Project Title: Zone File #2015-0050: Addendum to the Final Negative Declaration for the North Davis Meadows Potable Water Connection Project.

**Addendum to Initial Study/Negative Declaration
(SCH# 2015112048)**

**North Davis Meadows Water Consolidation Project
February 2018**

Figure 1

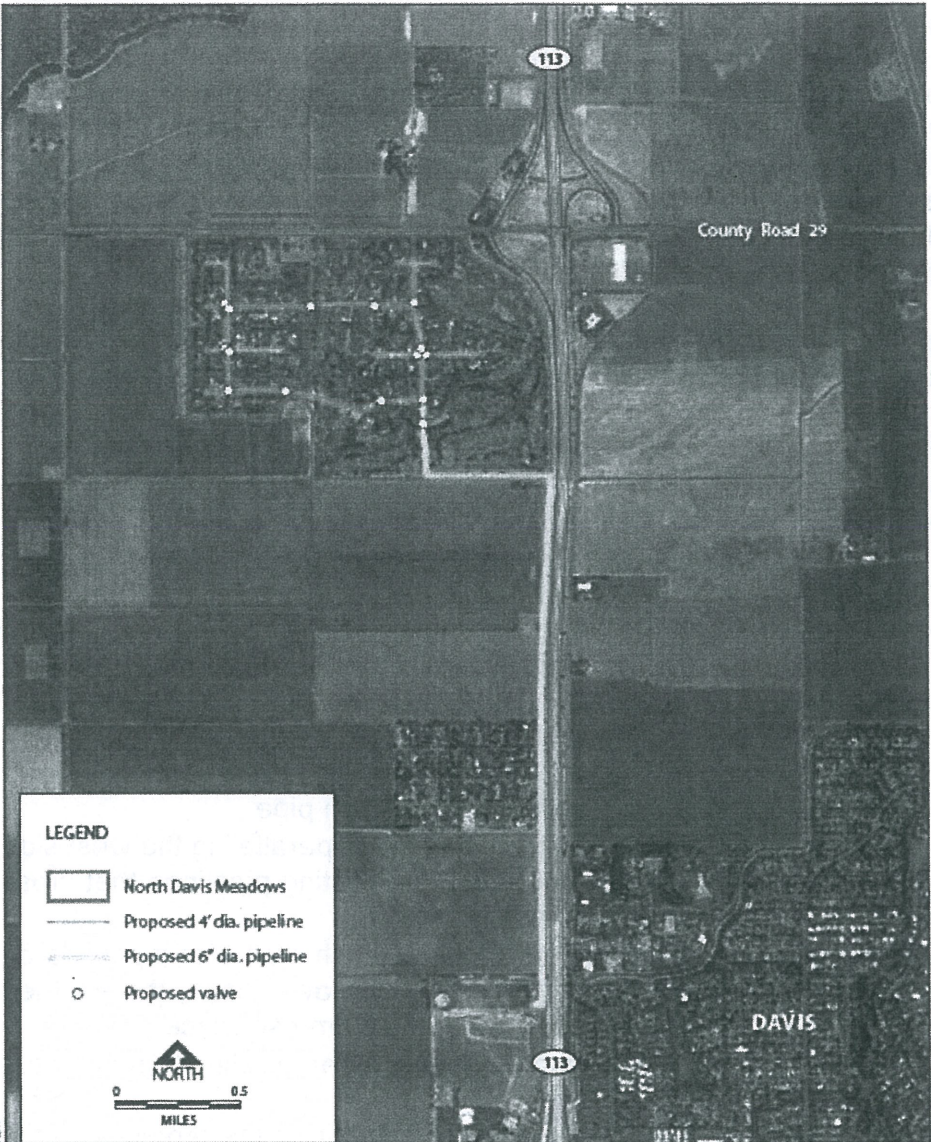
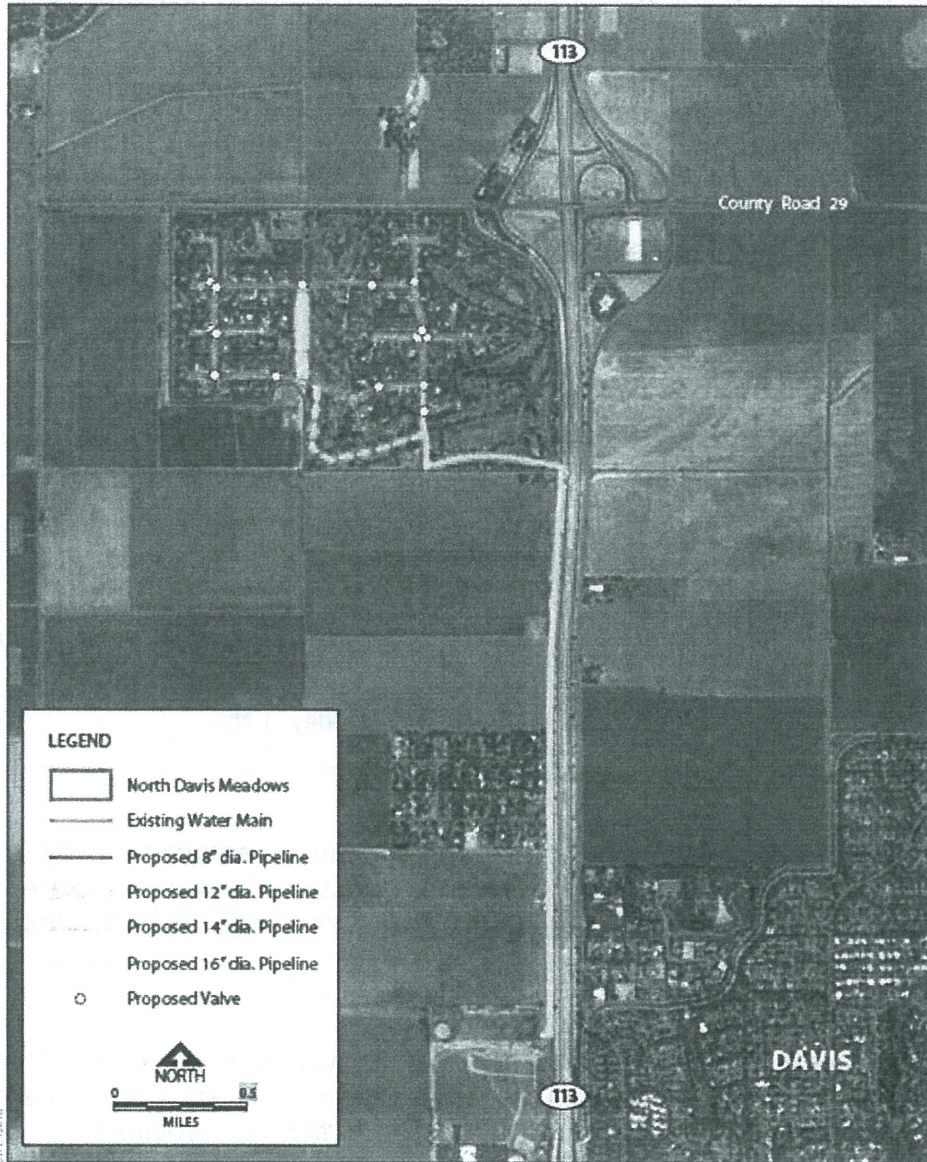
- Increasing the diameter of the pipeline from 6 inches to 16 inches, extending from its tie-in at the City of Davis West Tank Area and extending north for approximately 1 mile along John Jones Road/CR99D where it turns west along the fence line south of the Davis Municipal Golf Course, and then north onto Fairway Drive.

- Installation of approximately 300 feet of 12-inch diameter pipe from the connection at Fairway Drive to tie into the south end of the existing water main on Fairway Drive.

- Construction of an additional 14-inch diameter pipeline towards the west, along the southerly portion of the Davis Community Golf Course, between the 16-inch diameter main at Fairway Drive and the existing 6-inch diameter pipeline that runs west from Primrose Place to Spanish Bay Place.

- Replacement of the portion of the existing 6-inch diameter pipe from that connection point to Spanish Bay Place with a new 12-inch pipe.
- Installation of an additional 12-inch diameter water main, paralleling the west side of the Davis Community Golf Course to connect the existing pipelines that cross the golf course in order to meet fire flow requirements

- Upsizing existing 6-inch diameter pipelines to new 8-inch diameter pipelines on Silverado Drive, between Granite Bay Place and Blackhawk Place, the east leg of Spyglass Place, Larkspur Place, Lupine Court, and Primrose Place.

- Relocation of two fire hydrants so they can be served by an existing 8-inch pipe.

Figure 1 presents the original project site plan depicted in the IS/ND; **Figure 2** shows the proposed, modified site plan.
